## Design Improvement

DAF111D

to fit: DAF: XF95, 105 series, CF65, CF75, CF85 series

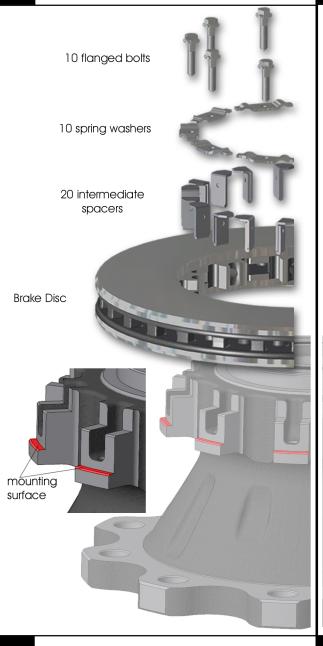
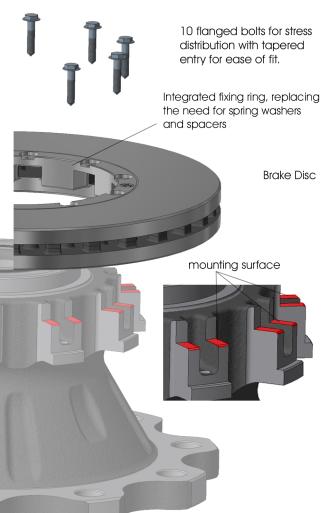
The original design has 20 intermediate spacers that can be difficult to install and even more difficult to remove along with 10 spring washers.

The original design is mounted on a small surface area and is prone to excessive wear. Excessive wear to this area can cause the disc to become loose.

The JURATEK design reduces the fitting and removal times due to the *integrated fitting ring* and increases the strength of the fitting. This increased strength comes from the inner splines being increased in width and the weight reduction space being filled. This can prevent the splines from separating from the disc when under stress.

The JURATEK design is mounted on a different section of the hub and is a larger surface area. A greater surface area has much less wear potential. This new fixing method allows full clamping load to be applied directly to the new mounting face, so minimising the risk of torsional movement between disc and hub. Using this new mounting surface also means a new disc can be fitted to a previoulsy worn
